Customer : CU-DAR001 Dart Helicopters Services Drawing Name : HELI UTILITY BASKET LH/RH 350/355
 Job Number : 36832
 Estimate Number : 10208
 P.O. Number :
 This Issue : 1/17/2008 S.O. No. :
 Prsht Rev. : NC Part Number : D350607043
 First Issue : / / Type : LARGE FAB ASSY Drawing Number : D350-607 REV F P7-9
 Previous Run : 36740 Project Number : N/A
 Material :
 Due Date : 2/5/2008 Qty: 1 Um: Each
 Written By :
 Checked & Approved By :
 Comment : Est Rev:E as Per DSI9318 06-01-24 JLM
 Est Rev:F ECN1068 07-12-21 DD

DESIGN <i>CP</i>	DRAWN BY <i>CP</i>	DART AEROSPACE LTD HAWKESBURY, ONTARIO, CANADA	
CHECKED <i>[Signature]</i>	APPROVED <i>[Signature]</i>	DRAWING NO. DSI 9318	REV. A SHEET 1 OF 1
DATE 06.01.06		TITLE WASHER ADDITION	SCALE NTS
A	06.01.06	NEW ISSUE

DART SERVICE INSTRUCTION

TO AMEND INSTALLATION INSTRUCTIONS D350-607 REV. F

Figure 5- Basket Replacement Parts
(D350-607-043 Heli-Utility-Basket™)

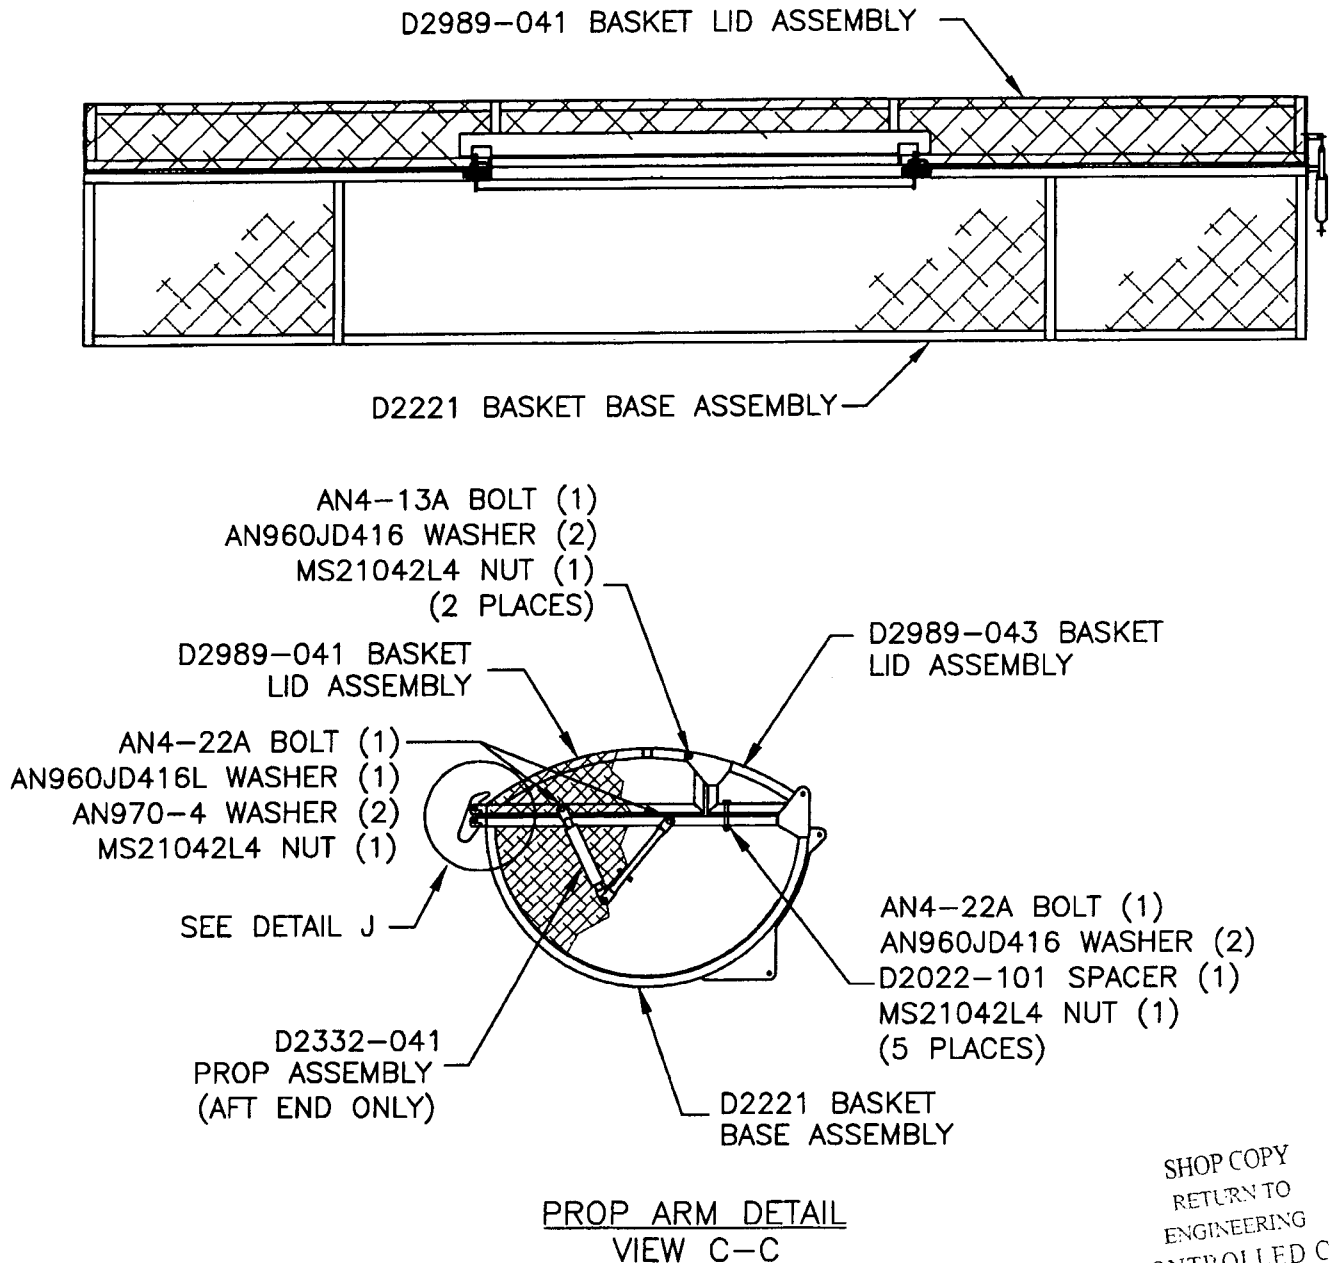
The corrected bolt stackup from Figure 5 of installation instructions D350-607 Rev. F is given below:

AN4-13A BOLT (1)
AN960JD416 WASHER (1)
HINGE PLATE (REF)
NAS1515H4 WASHER (1)
BASKET FRAME (REF)
AN960JD416 WASHER (1)
MS21042L4 NUT (1)
(2 PLACES)

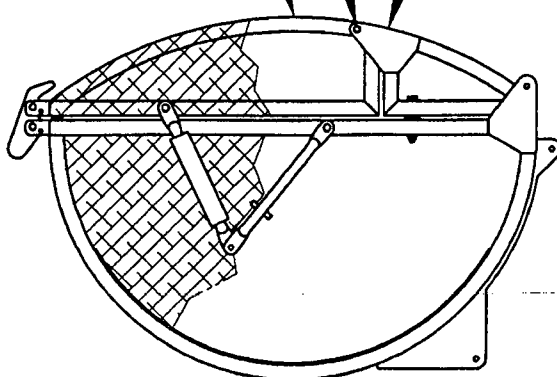
To reduce the possibility of damaging the finish, a **NAS1515H4** washer (2 places) has been added between the hinge plate and basket frame on the **D350-607-043/-047 Heli-Utility-Basket**.
